International Aero Engines

SERVICE BULLETIN

<u>ENGINE - FUEL AND CONTROL - FUEL AND CONTROL - INCORPORATE BURNER PRESSURE (PB) SENSOR</u>

TUBES WITH REVISED MOISTURE TRAPS - CATEGORY CODE 6 - MOD.ENG-73-0019

PB Air Tubes and Clipping Details - After Alteration Fig.2, Sheet 1 of 3

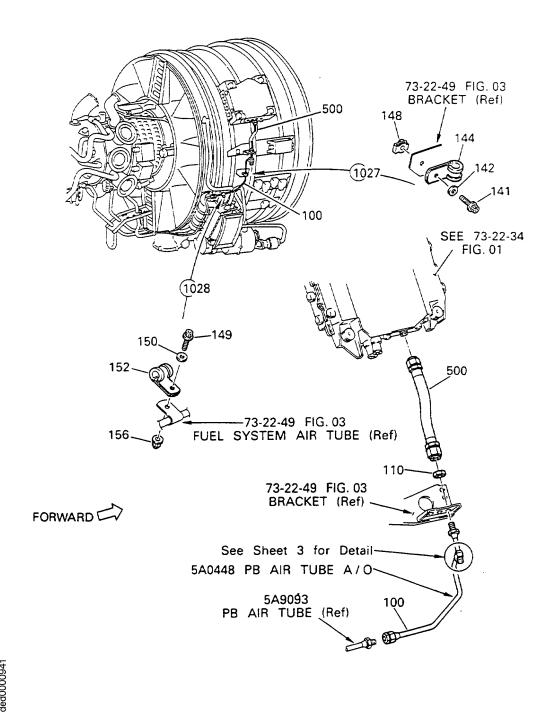
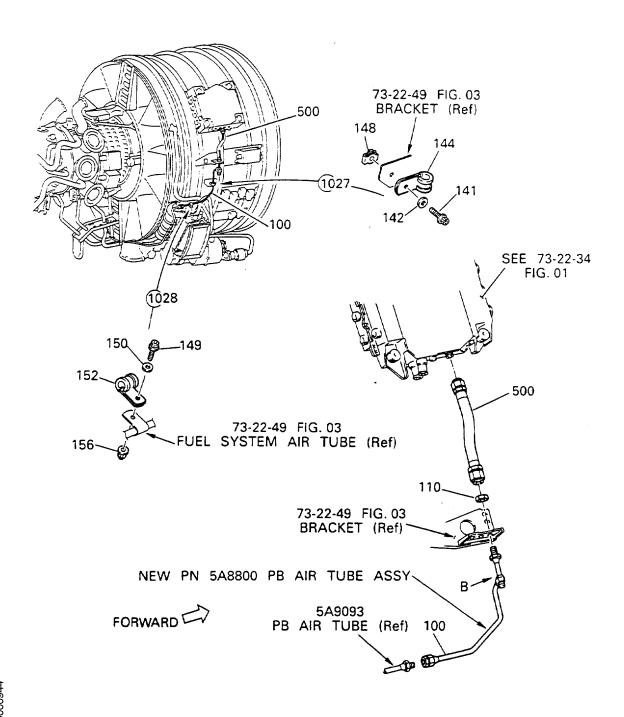
(a) The Removal/Installation of the Post-Service Bulletin configuration require revision of the Engine Manual under chapter 72-00-32, removal and Installation to show the new clipping position VCP1118 and the revised clipping configuration at CP0544 and CP0565.

- (2) At new VCP1118, install new 400WSS12, Clip, new 400WSS4, Clip, the two new 5W1086, Washers, new 4W0104, Bolt, and new 4W0001, Nut, to the Scavenge Oil Tube and the PB Air Tube. Torque the Nut to 36 45 lbfin (4,00 5,00 Nm). (Refer to Figure 2, Sheet 1, and 1.K.(400)).

- (3) At CPO565, install the Clips, the Washers, the Bolt, and the Nut, to the Lug on Scavenge Oil Tube by the approved procedures in the Engine Manual, 72-00-32, Installation, but 400WSS4, Clip, must be turned to safety the rerouted new PB Air Tube. (Refer to Figure 2, Sheet 1, and 1.K.(3)).

PB Air Tubes and Clipping Details - After Alteration Fig.2, Sheet 3 of 3

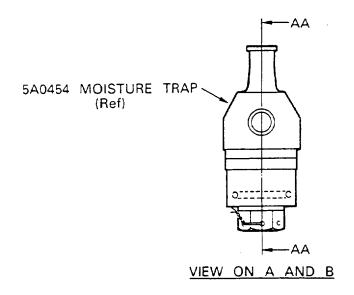
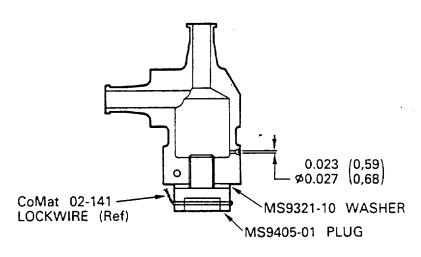
- (a) New PB Air Tubes which have the new designed moisture traps having the clean-out plug and washer at the bottom and 0.023 0.027 in. (0,59 0,68 mm.) in diameter of the drain hole on its side wall have been introduced. (See Figure 2, Sheet 3).
- (b) The PB Air Tube adjacent to the Bifurcation Panel has been rerouted to relocate the moisture trap to the lowest position in the PB Air Tube. (See Figure 2, Sheet 1).
 - (c) The clip which safeties the PB Air Tube at CP0544 has been deleted because of rerouting of the PB Air Tube. (See Figure 2, Sheet 1).
 - (d) New clipping position CP1118 has been introduced to safety the new PB Air Tube. (See Figure 2, Sheet 1).
- (1) New PB Air Tubes, new drain plugs and washers are available for future replacement purposes.
